2. APPLICATION TO ALTER 227 MACKAY STREET, A PROPERTY LOCATED IN THE NEW EDINBURGH HERITAGE CONSERVATION DISTRICT, DESIGNATED UNDER PART V OF THE *ONTARIO HERITAGE ACT*

Manager's report, Right of Way, Heritage and Urban Design Services, Planning, Infrastructure and Economic Development Department dated 11 August 2017 (ACS2017-PIE-RHU-0018)

Ward: RIDEAU-ROCKCLIFFE (13) File Number: ACS2017-PIE-RHU-0018

SUBJECT: Application to Alter 227 Mackay Street, a property located in the New

Document 5 - Details on Temporary Removal / Foundations

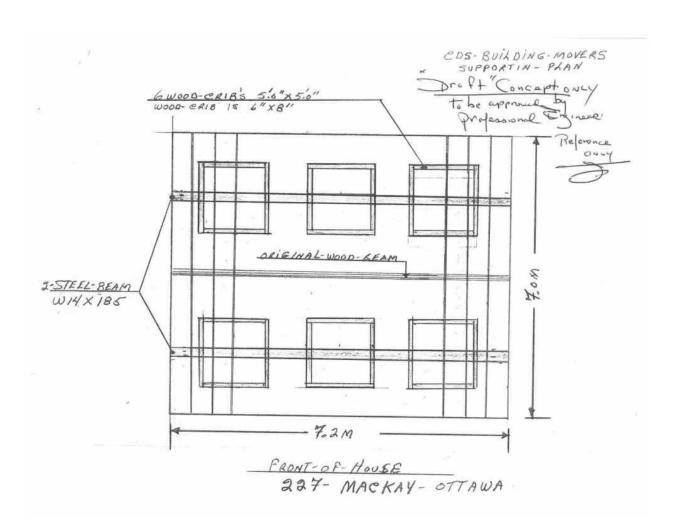
The house at 227 MacKay Street is a balloon frame structure resting upon its original concrete foundation. (For Heritage Survey Form, see Document 3.) In recent years, there has been water infiltration into the basement, creating damp conditions and significant deterioration of the foundations. The current proposal includes the temporary moving of the original portion of the house to the backyard, the complete removal of the original foundations and the construction of new foundations that will include an eightinch slab and the installation of a waterproof membrane. The new foundations will extend to the full extent of the proposed new addition to the house.

The condition of the original foundations was a major concern for the property owners. In order to ensure the retention of the original house, it was determined that in this instance the replacement of the foundations was the best way to fulfill the requirement of the reuse of existing buildings, rather than their demolition. An illustration of the moving process is included as Document 5.
